To: CRA Board and Planning Board
Subject: Center Plaza Design Update
Date: August 5th, 2025

Plaza CRA/CDD Design Review Committee

CENTER PLAZA DESIGN UPDATE

Design Review Committee Discussion
August 19, 2025

(VISUAL MOCKUP)

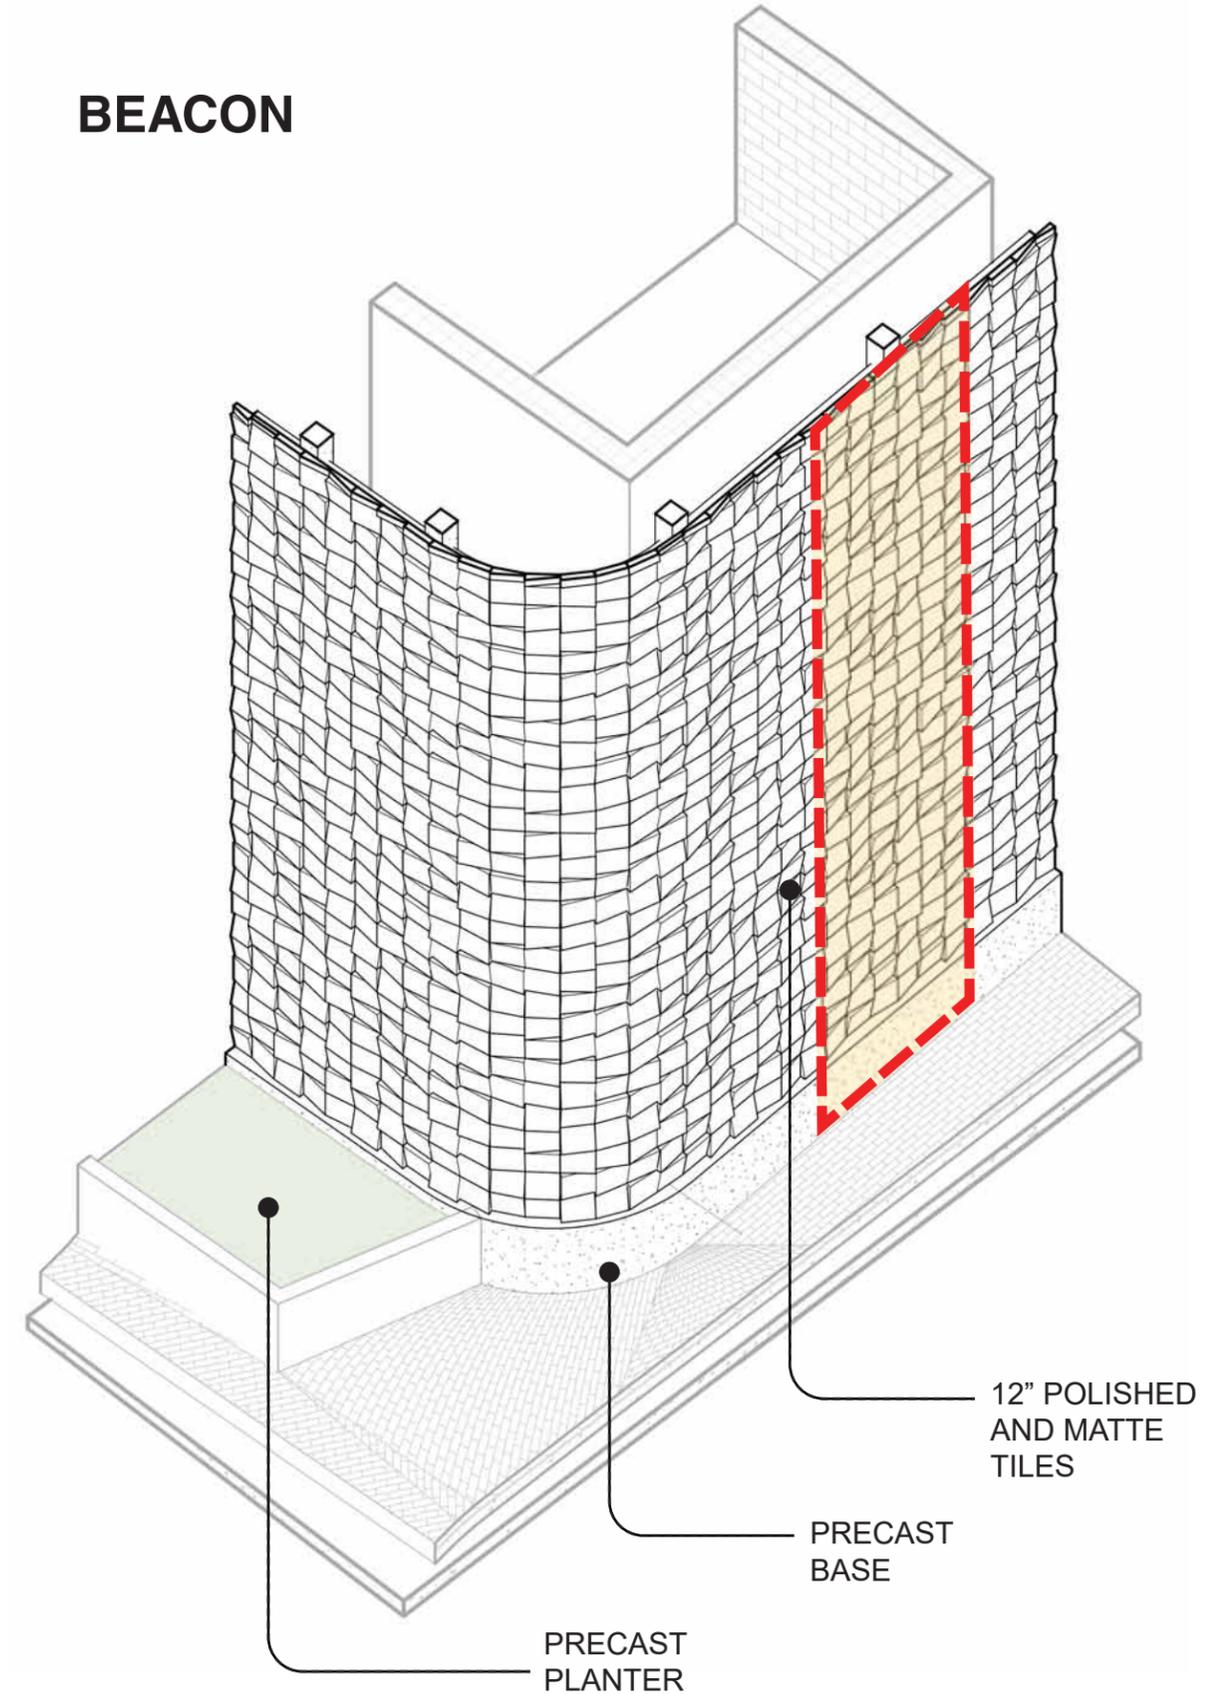
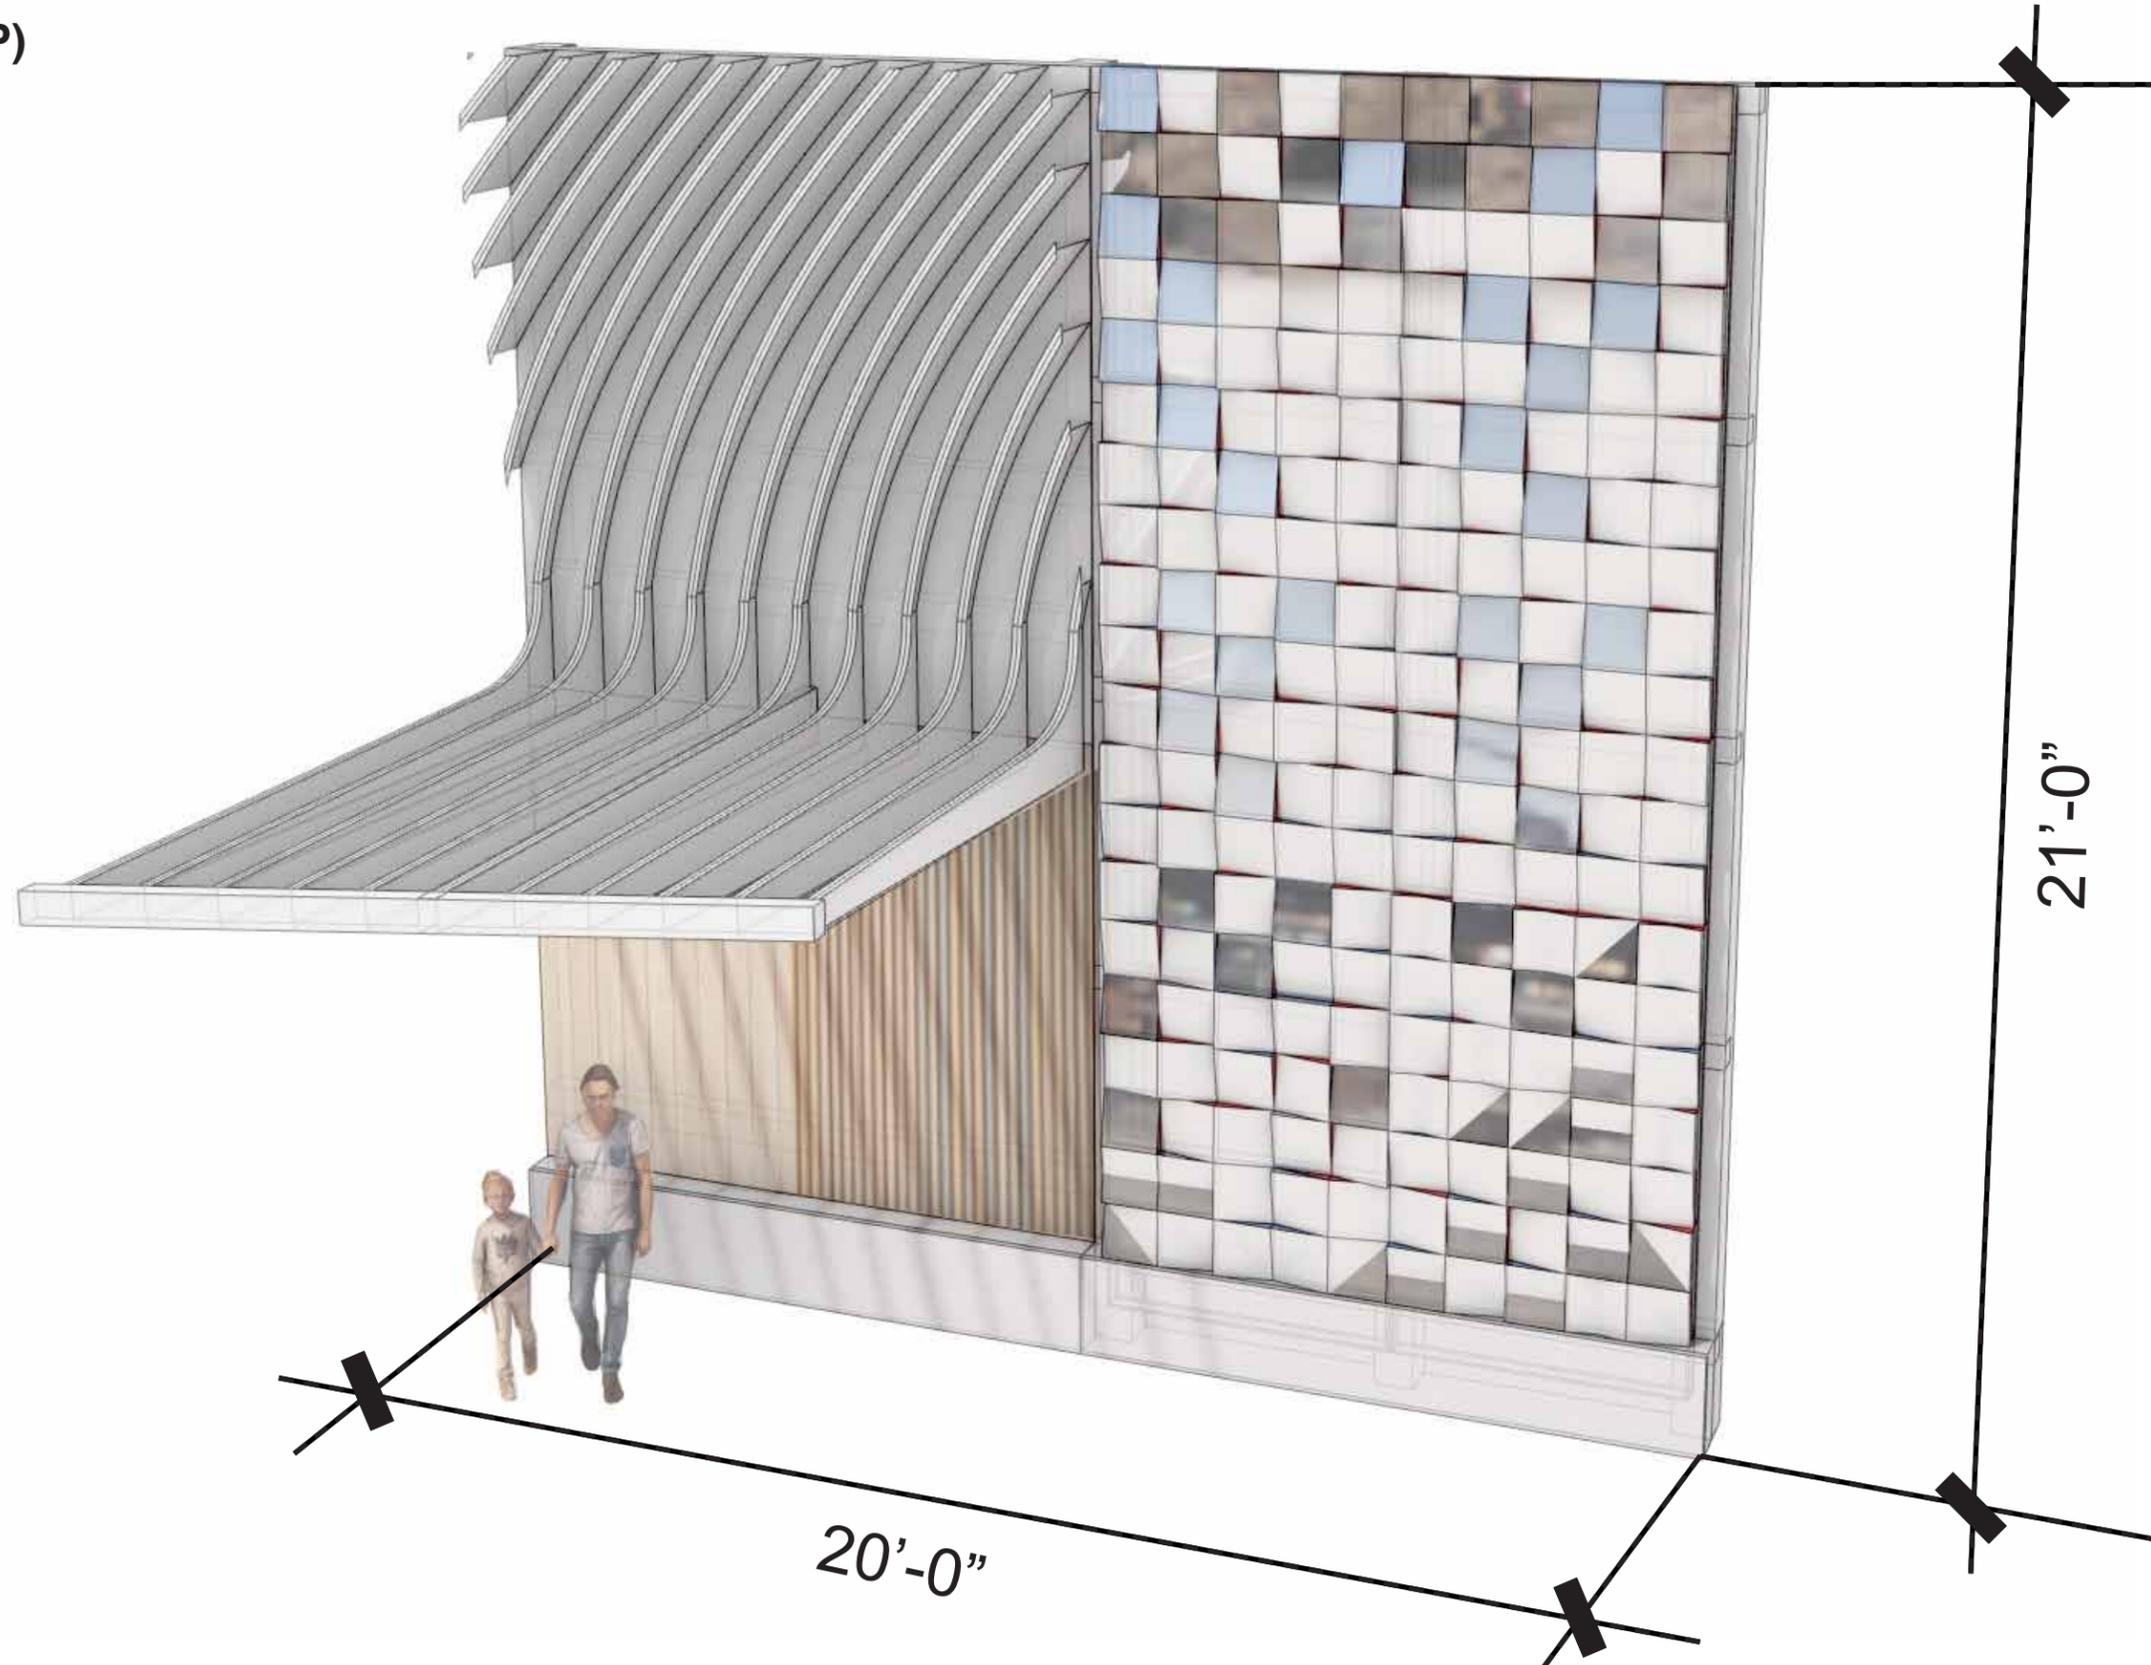
1. Provide mockups for structures (Beacon, Intake, Exhaust, and Trellis)
